Access Compliance Report

Public Rights-of-Way

(Curb Ramps)

Intersection ID: 10033028	Main Street: NOBLES_AV	Cross Street: N/A	Location: NE
ADA ID: 4899E48F6638	Ramp Type: Perp	Initial Pass/Fail: Fail	Overall Compliance: No
Severity Score: 13.75			
Codes/Mitigation Info/Possible Solution		Field Measurements/Component Compliance

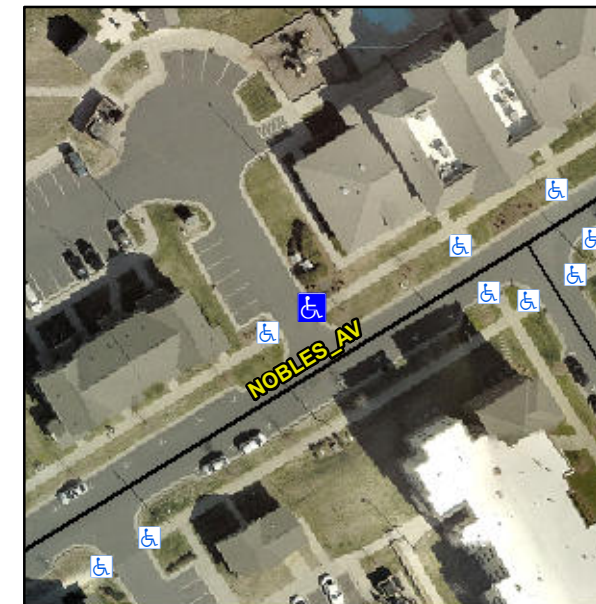
R304.2.2, R304.5.3

Compliance	Description	Data	Compliance	Description	Data
N/A	Ramp Length (in)	71.5	No	Ramp Slope (%)	10.9
Yes	Ramp Width (in)	70.0	No	Ramp XSlope (%)	3.5
N/A	Flare Type LT	N/A	N/A	Flare Type RT	N/A
N/A	Flare Slope LT (%)	N/A	N/A	Flare Slope RT (%)	N/A
N/A	Flare Traversable LT?	N/A	N/A	Flare Traversable RT?	N/A
N/A	Landing Length (in)	N/A	N/A	DWS Provided?	N/A
N/A	Landing Width (in)	N/A	N/A	DWS Contrast?	N/A
N/A	Landing Slope (%)	N/A	N/A	DWS Length (in)	N/A
N/A	Landing X Slope (%)	N/A	N/A	DWS Full Width?	N/A
N/A	Landing Curb? (Y/N)	N/A	N/A	DWS Offset (in)	N/A
N/A	Shared Landing?	N/A			
N/A	Gutter Ponding?	N/A	N/A	Gutter Slope (%)	N/A
N/A	Gutter Lip Ht (in)	N/A	N/A	Gutter X Slope (%)	N/A
N/A	Painted X Walk1?	No	N/A	Painted X Walk2?	N/A
	X Walk 1 Direction	To W		X Walk 2 Direction	N/A
N/A	X Walk 1 Width (in)	N/A	N/A	X Walk 2 Width (in)	N/A
	X Walk 1 Slope (%)	0.9		X Walk 2 Slope (%)	N/A
	X Walk 1 X Slope (%)	0.7		X Walk 2 X Slope (%)	N/A

Remove & Replace Entire Ramp.
